Access Compliance Report

Public Rights-of-Way

(Curb Ramps)

Intersection ID: 28389	Main Street: ARDREY_KELL_RD	Cross Street: LANCASTER_HY	Location: SW
ADA ID: AFD9EF3D6F56	Ramp Type: Para	Initial Pass/Fail: Fail	Overall Compliance: No
Codes/Mitigation Info/Possible Solution		Field Measurements/Component Compliance	
Severity Score: 1.25

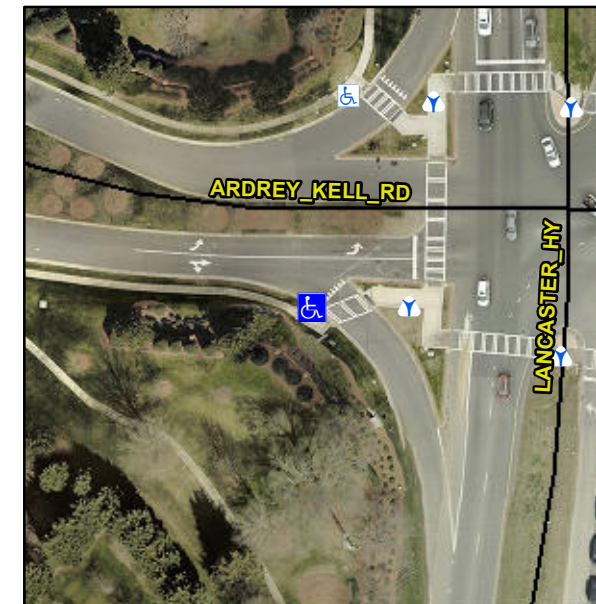
R304.5.3

Compliance	Description	Data	Compliance	Description	Data
N/A	Ramp Length LT (in)	N/A	N/A	Ramp Length RT (in)	139.0
N/A	Ramp Width LT (in)	N/A	Yes	Ramp Width RT (in)	58.0
N/A	Ramp Slope LT (%)	N/A	Yes	Ramp Slope RT (%)	6.9
N/A	Ramp XSlope LT (%)	N/A	No	Ramp XSlope RT (%)	2.8
N/A	Landing Length (in)	N/A	N/A	DWS Provided?	N/A
N/A	Landing Width (in)	N/A	N/A	DWS Contrast?	N/A
N/A	Landing Slope (%)	N/A	N/A	DWS Length (in)	N/A
N/A	Landing X Slope (%)	N/A	N/A	DWS Full Width?	N/A
N/A	Landing Curb? (Y/N)	N/A	N/A	DWS Offset (in)	N/A
N/A	Shared Landing?	N/A			
N/A	Gutter Ponding?	N/A	N/A	Gutter Slope (%)	N/A
N/A	Gutter Lip Ht (in)	N/A	N/A	Gutter X Slope (%)	N/A
N/A	Painted X Walk1?	Yes	N/A	Painted X Walk2?	N/A
	X Walk 1 Direction	To NE		X Walk 2 Direction	N/A
N/A	X Walk 1 Width (in)	128.0	N/A	X Walk 2 Width (in)	N/A
	X Walk 1 Slope (%)	1.9		X Walk 2 Slope (%)	N/A
	X Walk 1 X Slope (%)	1.6		X Walk 2 X Slope (%)	N/A
N/A	Ramp inside XWalk1?	Yes	N/A	Ramp inside XWalk2?	N/A

Remove & Replace Entire Ramp.
